PCI-SIG DRAFT ENGINEERING CHANGE NOTICE

TITLE:	Async Hot-Plug Updates
DATE:	Aug 27, 2018
AFFECTED DOCUMENT:	PCIe 4.0 Base Specification
SPONSORS:	Joe Cowan; Hewlett Packard Enterprise Austin Bolen; Dell EMC Dave Harriman; Intel Corporation

Figure 2-xx: ERR COR Message Request Header

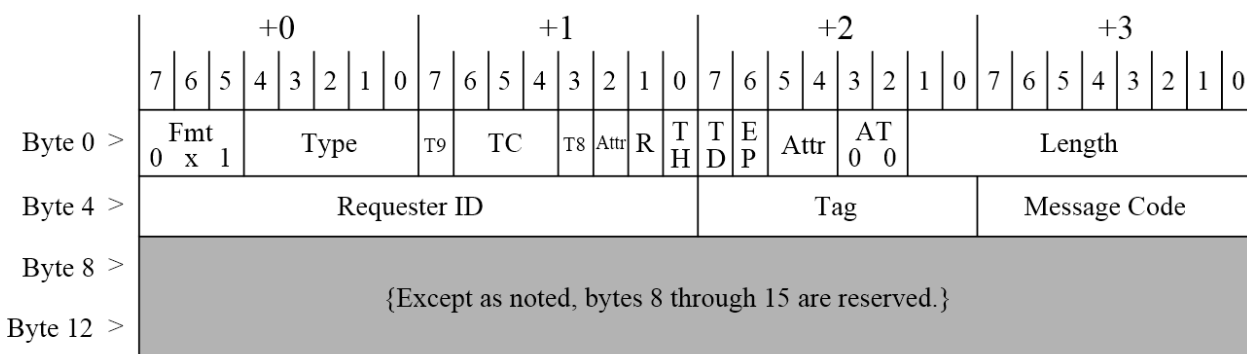
Note to Editor: Please create a new figure by leveraging the preceding existing figure to add a 2-bit ECS field in bits 7:6 of byte 8. Also indicate a Message Code value of 0011 0000 and a Fmt field value of 001.

- ☐ The ERR COR Subclass (ECS) field is encoded as shown in Table 2-yy, indicating the ERR COR Message subclass.

Figure 7-25: Device Capabilities Register

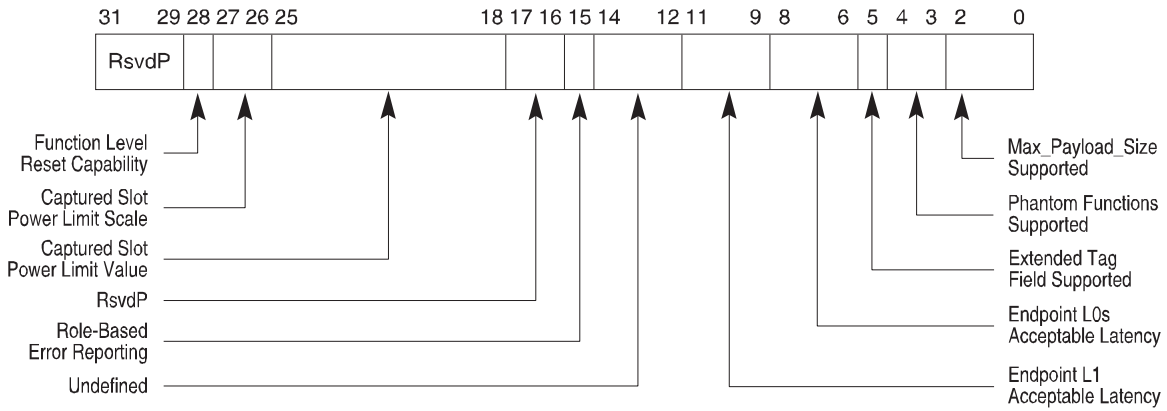
Note to Editor: Please update the preceding figure with the bit defined in the table below.

Bit Location	Register Description	Attributes
...
16	<p>ERR_COR Subclass Capable – When Set, this bit indicates that the Function supports the ERR_COR Subclass field in ERR_COR Messages, allowing different subclasses to be distinguished. See Section 2.2.8.3.</p> <p>Downstream Ports that implement the System Firmware Intermediary (SFI) capability must Set this bit. Downstream Ports that implement Downstream Port Containment (DPC) are strongly encouraged to Set this bit.</p>	RO

Figure 7-30: Slot Control Register

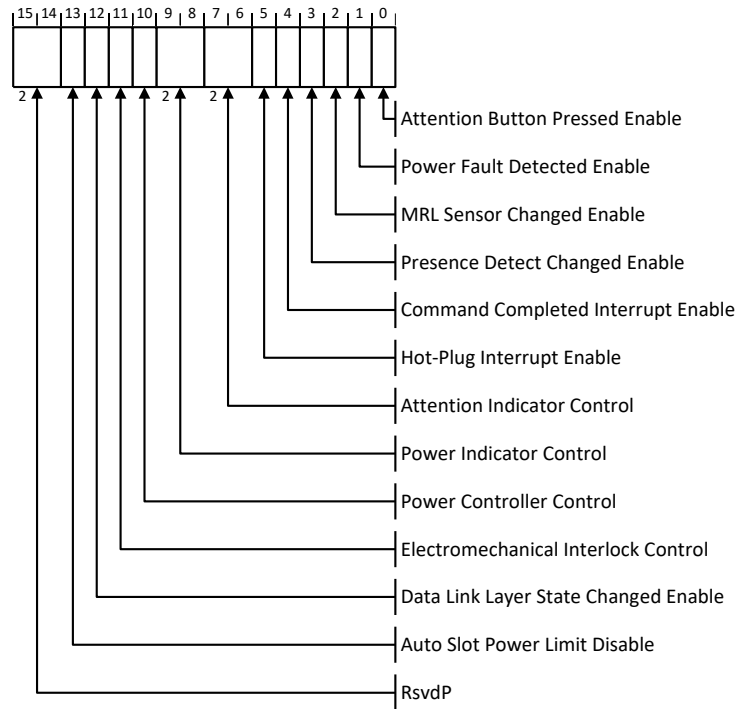
Note to Editor: Please update the preceding figure with the bit defined in the table below.

Bit Location	Register Description	Attributes
...
14	<p>In-Band PD Disable – When Set, this bit disables the in-band presence detect mechanism from affecting the Presence Detect State bit, allowing that bit to report out-of-band presence detect exclusively. Otherwise, the Presence Detect State bit reflects the logical OR of the inband and out-of-band presence detect mechanisms.</p> <p>In addition, the In-Band PD Disable bit governs the Component Presence state for the Downstream Component Presence field in the Link Status 2 register.</p> <p>This bit must be implemented if the In-Band PD Disable Supported bit is 1b. Otherwise, this bit must be hardwired to 0b.</p> <p>Default value of this bit is 0b.</p>	RW

Figure 7-117: Root Error Status Register

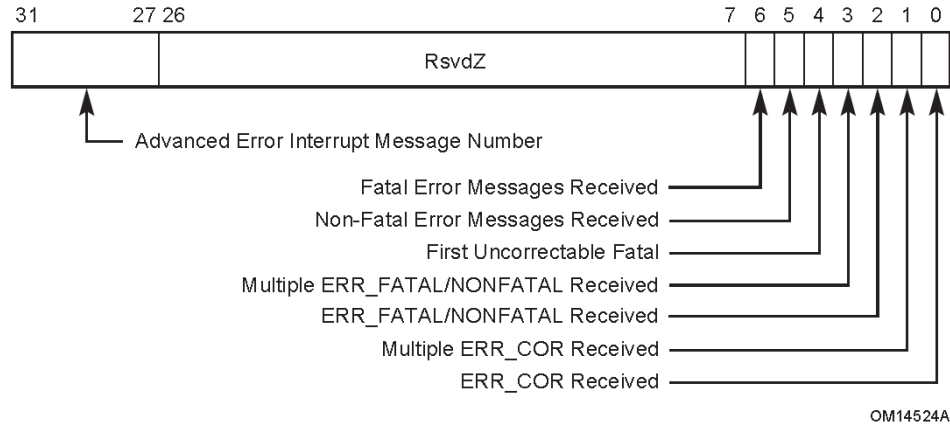
Note to Editor: Please update the preceding figure with the field defined in the table below.

Bit Location	Register Description	Attributes
...
8:7	<p>ERR_COR Subclass – If the Function is ERR_COR Subclass capable and the ERR_COR Received bit is not already Set, this field is loaded with the value of the ERR_COR Subclass field in the received ERR_COR Message. See Section 2.2.8.3. If the Function is not ERR_COR Subclass capable, this field is Reserved.</p> <p>If the Function is ERR_COR Subclass capable and a SIG_SFW_ERR_COR Message is received, system firmware should be signaled using a system-specific mechanism.</p> <p>Default value of this field is 00b.</p>	ROS / RO

Figure 7-234: DPC Status Register

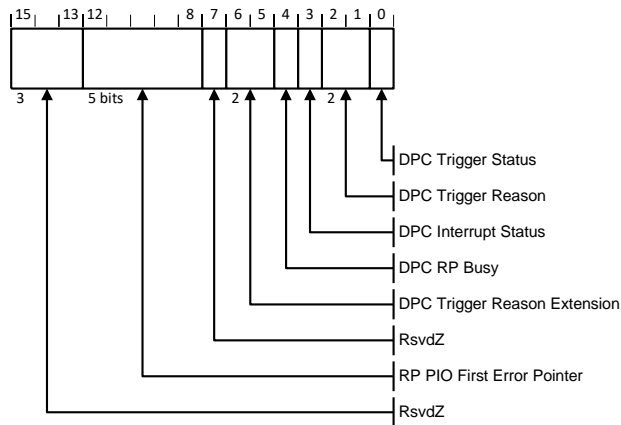
Note to Editor: Please update the preceding figure with the bit defined in the table below.

Bit Location	Register Description	Attributes
...
13	DPC SIG_SFW Status – If the Function supports ERR_COR Subclass capability, this bit must be implemented; otherwise, it must be hardwired to 0b. If implemented, this bit is Set when a SIG_SFW ERR_COR Message is sent to signal a DPC event. See Sections 6.2.10.2 and 6.2.10.5 . Default value of this bit is 0b.	RW1CS / RO
